## Fitting more FLASH to an Echelon

Echelon consoles with serial numbers up to and including B99xxx require additional FLASH memory to be fitted in order to run version 3 and later software. This tech note describes the modifications necessary to fit the CPU in these consoles with the larger FLASH devices.

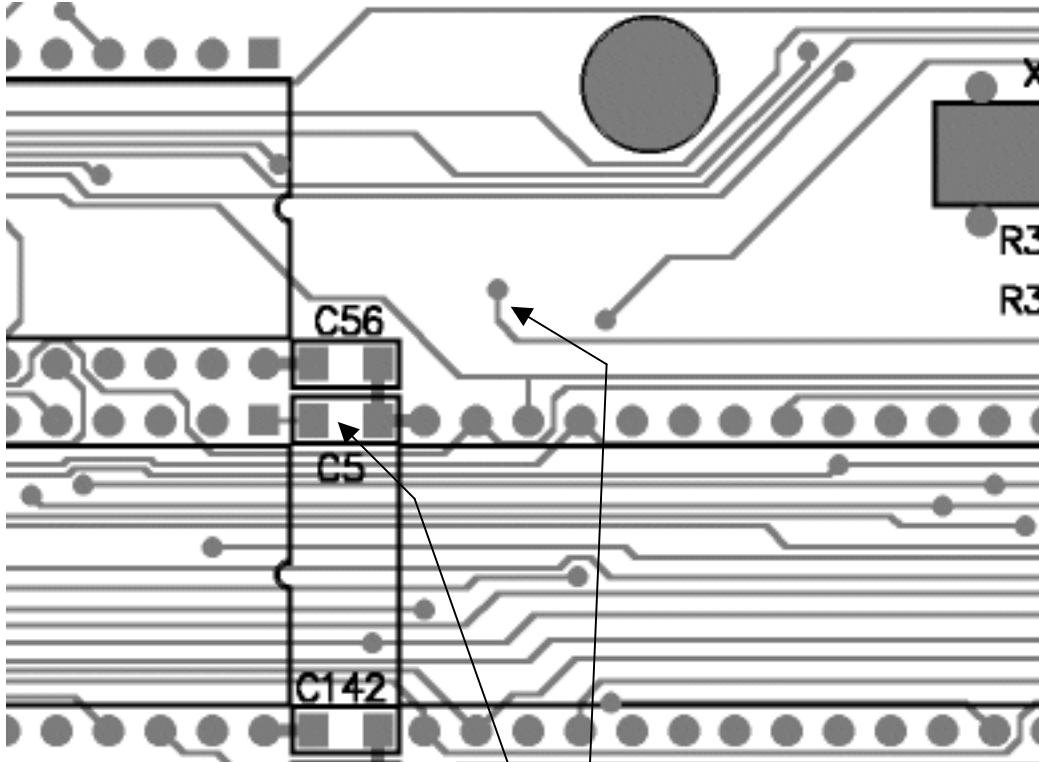
1. Save any show information
2. Switch off the console
3. Remove the base
4. Locate and remove the existing FLASH parts in sockets IC11, IC12, IC13, and IC14 near the centre of the CPU card
5. Insert the four replacement FLASH RAM ICs, noting orientation marks on the PCB
6. Locate and remove surface mount capacitors C2, C3, C4, and C5 near pin 1 of the sockets listed in step #4
7. Locate and remove the boot ROM in socket IC25
8. Insert the replacement boot ROM IC, noting orientation marks on the PCB
9. Solder a wire link between the positions as indicated on the diagram
10. Remove the jumper from J3
11. Hold the Enter button down while turning power on
12. Insert the operating software into the disk drive
13. Press 2 to select "Reload software"
14. Reload any saved show information

Insert link between points indicated, as viewed from the component side
